DENIAL OF PERMIT

WORK SITE LOCATION: 25 Raymond Road **REVISED :** February 26, 2021

On **December 16, 2020** our office reviewed a survey plan for a zoning permit which proposes a 1 story addition to an existing 2 1/2 story house at the above address.

FLYNN RESIDENCE PROPOSED HOUSE ADDITION 25 RAYMOND ROAD MORRIS TOWNSHIP, NEW JERSEY BLOCK 104 LOT 7

SITE PLAN
1" = 10'-0"

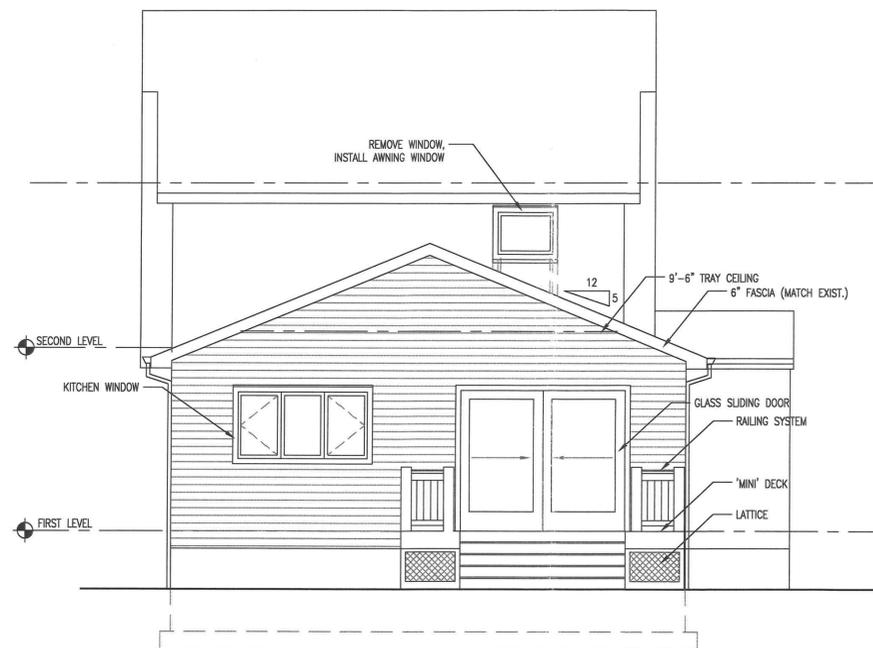
The survey/plan submitted contains a zoning information block on the title sheet of the construction plans however the zoning district is incorrect as are some of the bulk requirements criteria. The plan depicts the 1 story addition maintaining the existing substandard side yard setback of the right side of the property. The house and property are pre-existing and non-conforming conditions. The house was constructed in 1921. Based on our review of the plan, the following comments are warranted:

Construction of an addition on a pre-existing, non-conforming structure that encroaches side yard setback and substandard combined side yard total. Also expansion of a non-conforming structure.

This lot is located in the RA-7 Single Family Zone.

As per Township of Morris Zoning Ordinance 95-28 – area, bulk, and yard requirements - a minimum side yard of 10 ft. on one side is required and a combined side yard of both side yards a minimum of 20 feet is required. The existing house presently sits slightly skewed to the front and side property lines and, as noted, has a left side yard setback of 5.6 feet. The right side yard setback is noted as 12.0 to the front right corner of the existing structure and 11.6 feet to the right rear corner of the proposed addition. The existing combined side yard setback is 17.6 feet where 20 feet is required and the proposed combined side yards is proposed totaling 17.2’.

Pursuant to Chapter 95-29(A)2, the proposed addition also causes variance by expanding a non-conforming house. Board of Adjustment approvals will also be required for a reduced combined side yard setback. It should be further noted the proposed addition will not further encroach the left side line and no further encroachment is noted for the front of the house. A small deck is proposed for the rear of the addition which meets the side yard setbacks for the left and right side yards.

A "C" Variance Approvals from the Township of Morris Board of Adjustment pursuant to the above-referenced zoning chapter must be granted before a Construction Permits can be issued to allow for the expansion to be eligible for Building Permits. A Site Plan will be required indicating the addition sizes, existing and proposed setbacks and zoning data required by the Board of Adjustment application. This plan can be prepared by a licensed surveyor or Engineer. The above described plan must be submitted with the variance application and applicable fees and include floor plans and building elevations.
